Fire and Electrical Safety Assessment of Existing RMG Factory Buildings in Bangladesh

Kojima Lyric Garments Ltd.
(BGMEA Ref. # 407)
Chandna-Naljani, Joydebpur Road, Gazipur

Bureau of Research Testing and Consultancy (BRTC)
Bangladesh University of Engineering & Technology (BUET), Dhaka – 1000

Fire and Electrical Safety Assessment Report

P20.2 Non-standard hose system

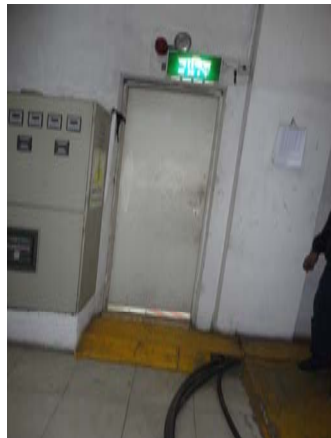
SI #	Item	BNBC2006 Reference	Guidelines Reference	Type of Non-Conformities	Actions	Time frame	Photo
20	Standpipe and Hose system	<ul style="list-style-type: none"> • §2.11 Page10368 • Table 3.2.6 Page 10371 • §4.2.1 Page10435 • §4.2.2 Page10435 • Table 4.4.1 Page 10436 • §4.2.2.4 Page10439 • §4.2.3 Page10439 • Table 4.4.2 Page 10442 		<ul style="list-style-type: none"> • Non standard Standpipe & Hose system • Supply of water required for interior fire protection is not adequate • Pressure in the standpipe is less than required • The size (diameter) of the standpipe is less than the prescribed value. • No Siamese connection available. 	<ul style="list-style-type: none"> • Provide standard Standpipe& Hose system that complies with the Guidelines requirements for supply of water, minimum pressure in the standpipe and size (diameter) of the standpipe. • Ensure that Siamese connections are available as specified by the Guidelines. 		P20.1 P20.2
